Request for Class II Permissive Change

FCC ID: **YZZGXP2124**

New mainboard photo view

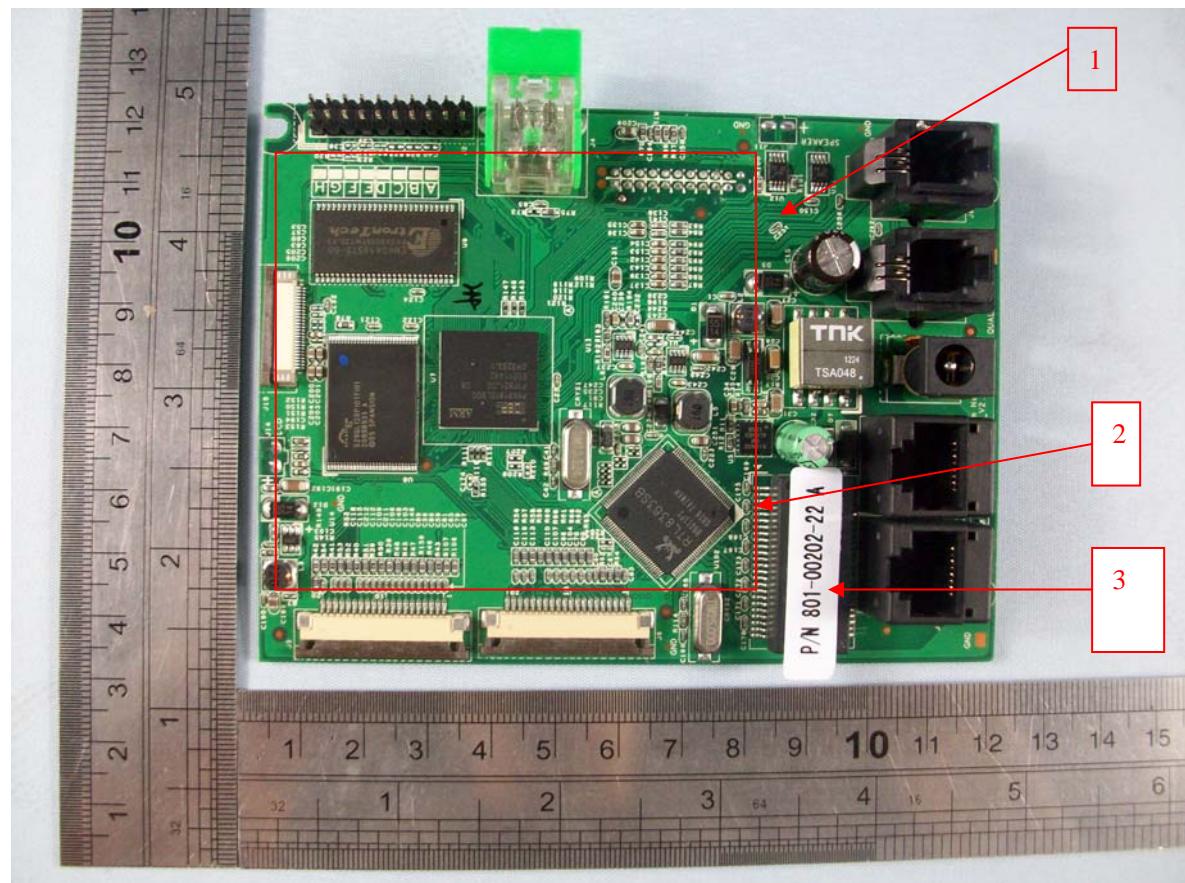
1. Upgraded mainboard hardware version from GXP2124 V1.3A to GXP2124 V2.X;
2. Changed component layout& PCB layout(see arrow 1);
3. Added an Ethernet IC(U102) which was used for upgrading from 100Mbps to 1000Mbps Ethernet(see arrow 2);
4. Changed Ethernet transformer IC(See arrow 3).
